ADDENDUM NO. 4  
TO THE  
DRAWINGS AND PROJECT MANUAL  
FOR  
**NEW OPPORTUNITY AWARENESS CENTER  
KATY INDEPENDENT SCHOOL DISTRICT  
KATY, TEXAS**

06/17/2026

#### CIVIL CONSULTANT, ADDENDUM No. 4

P1.11

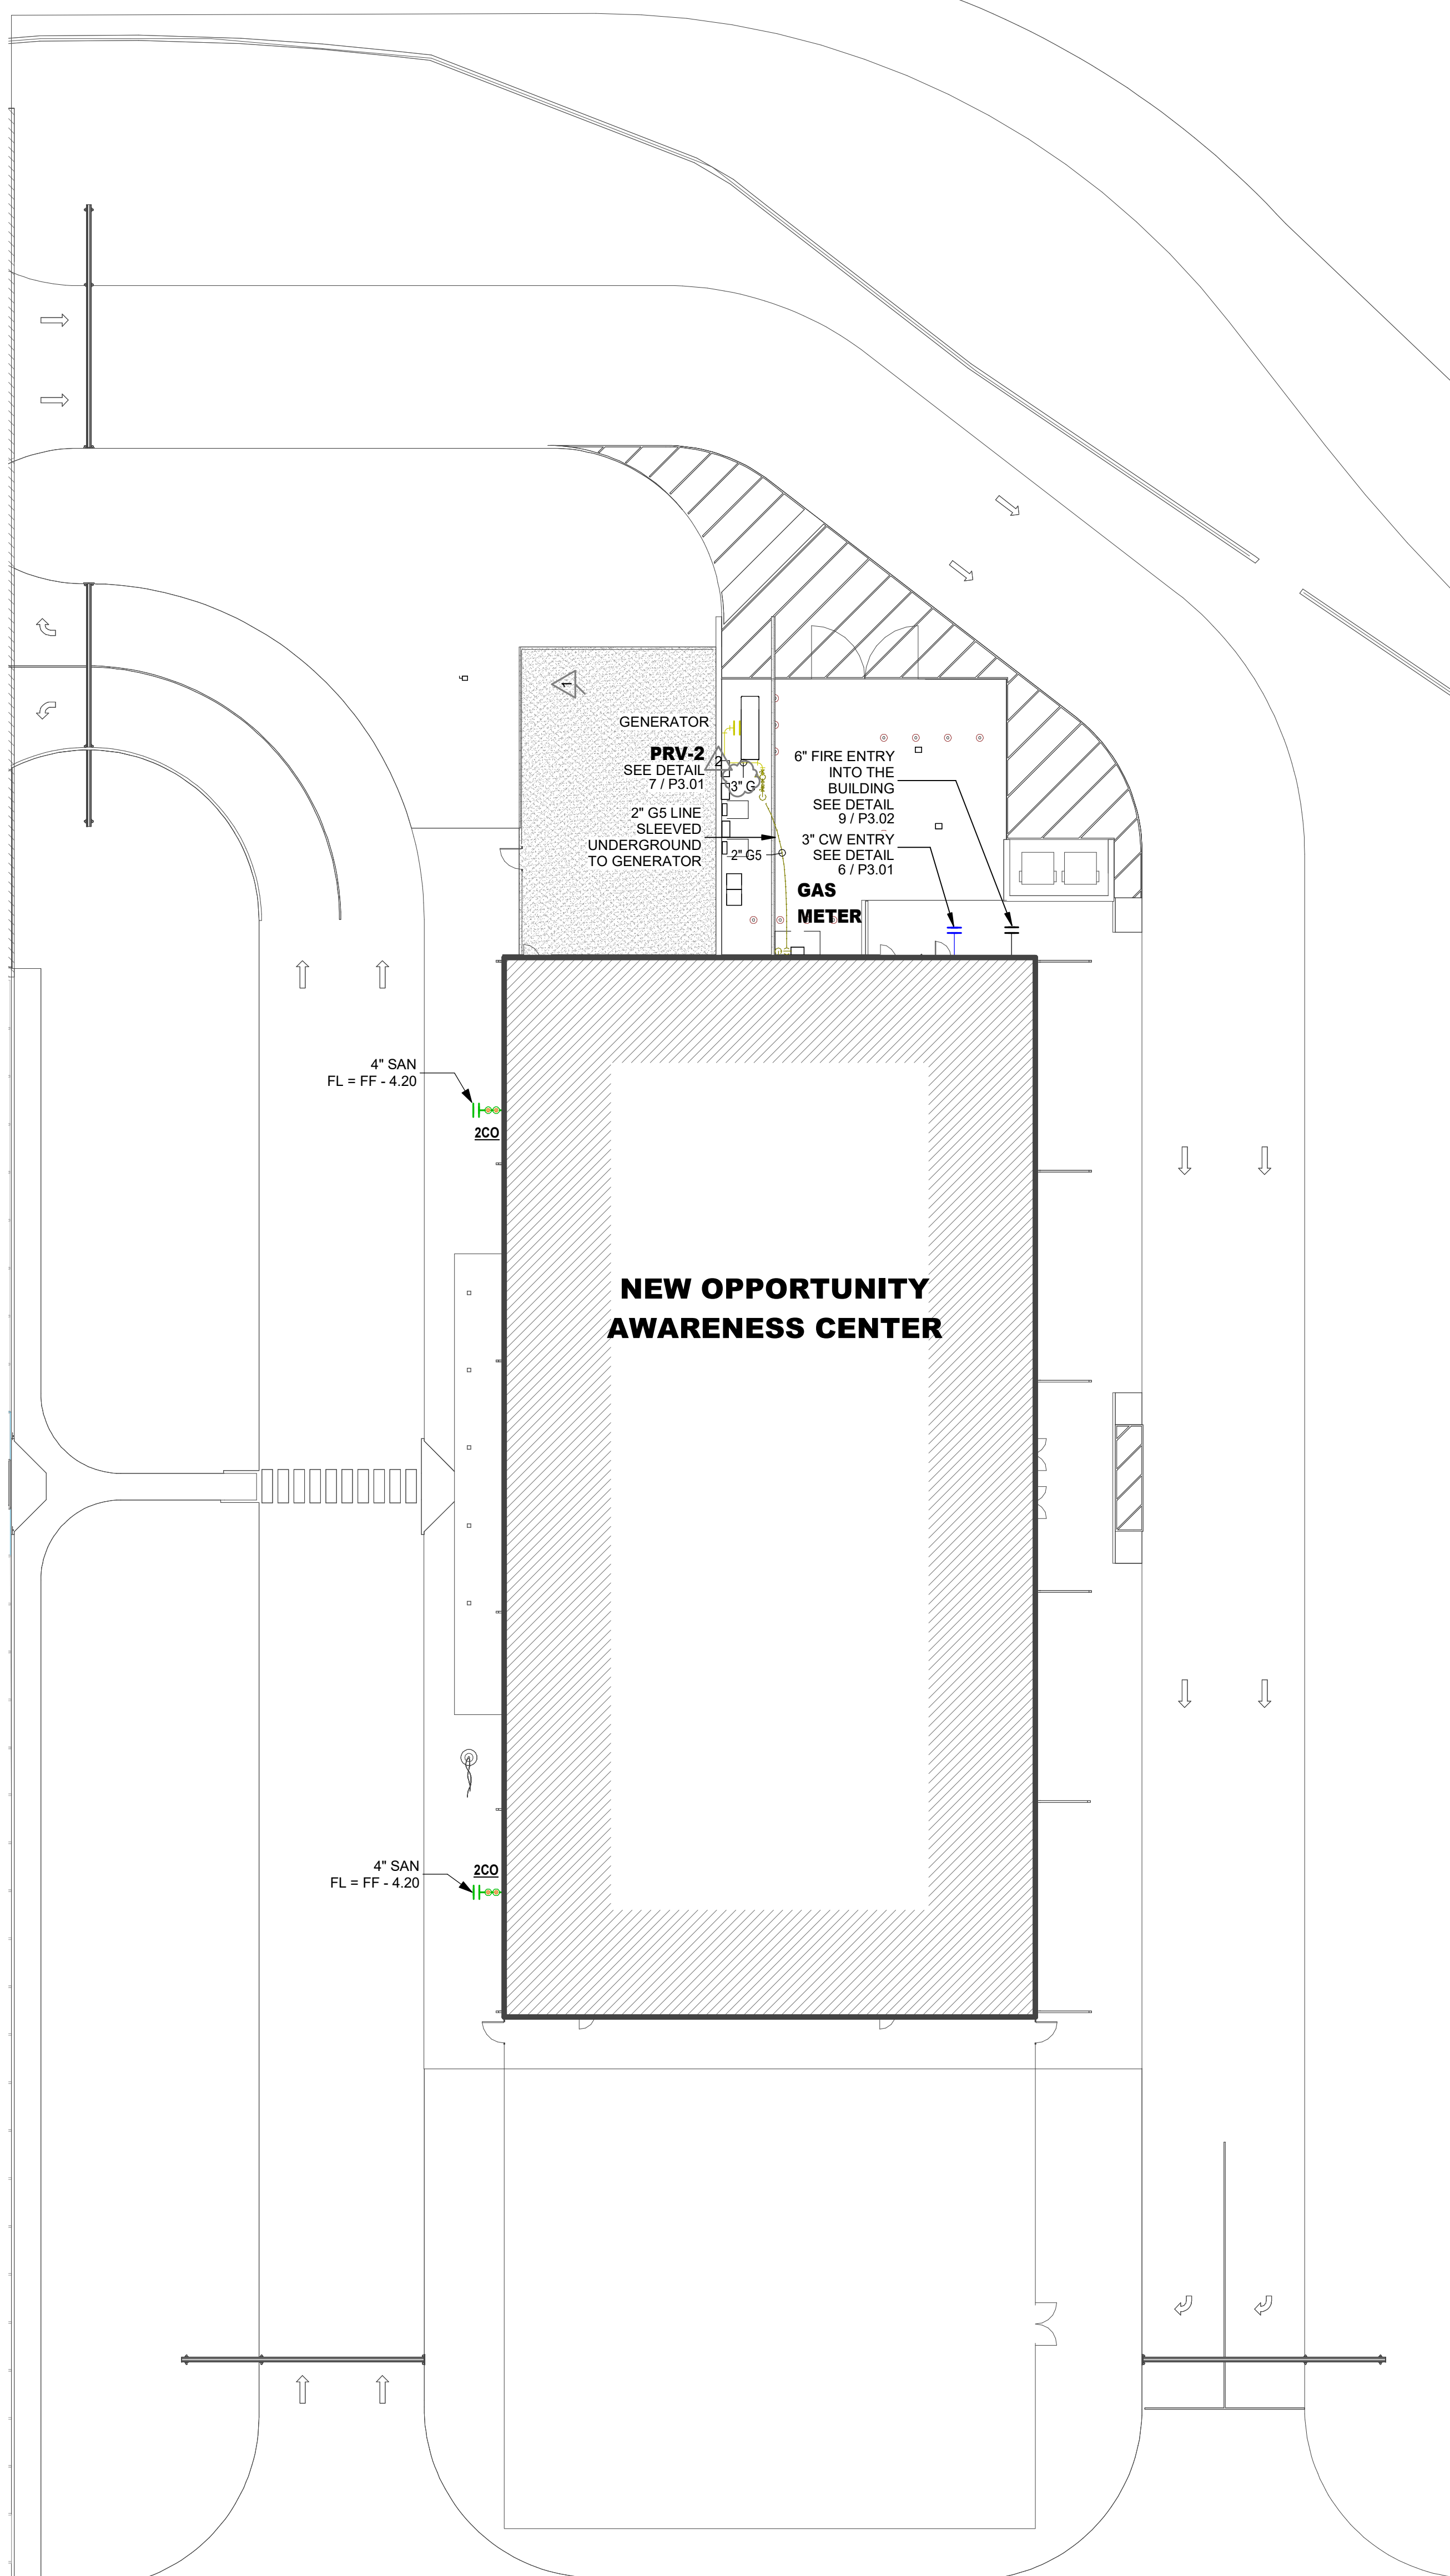
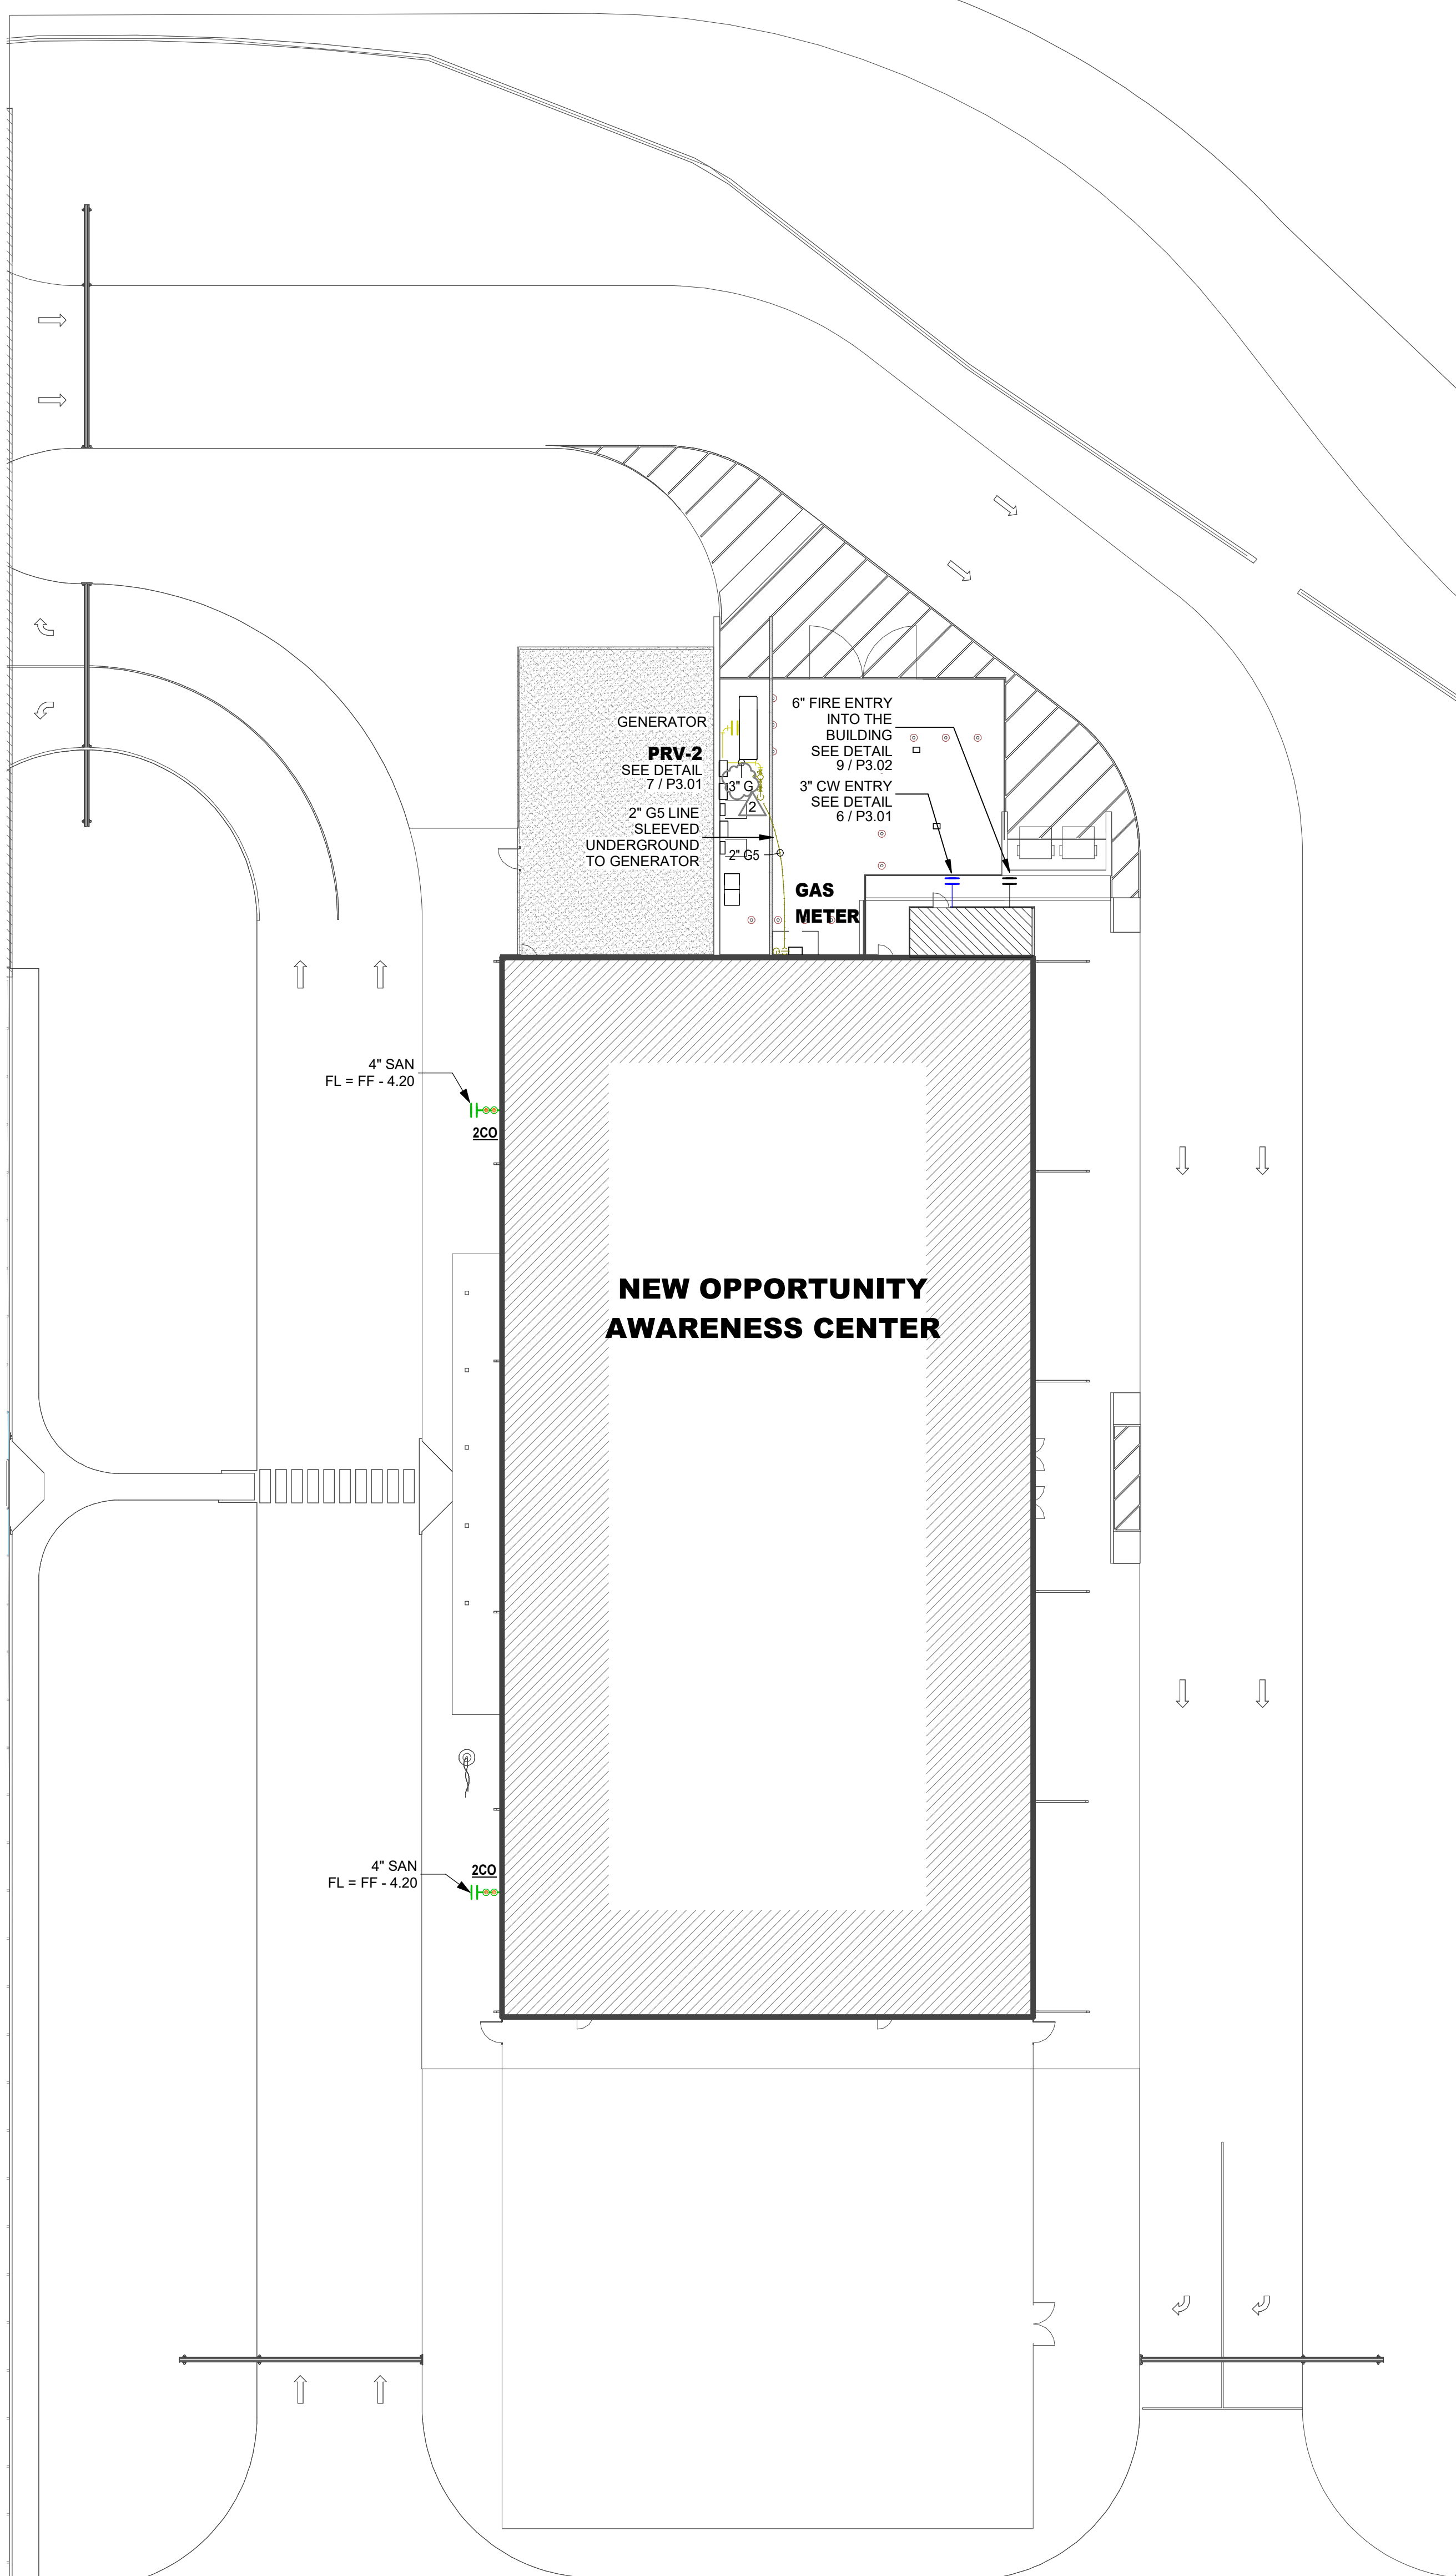
**8. SHEET P1.11 — PLUMBING SITE PLAN**

- A. Modified gas pipe size after the PRV for the generator from 2” to 3”.
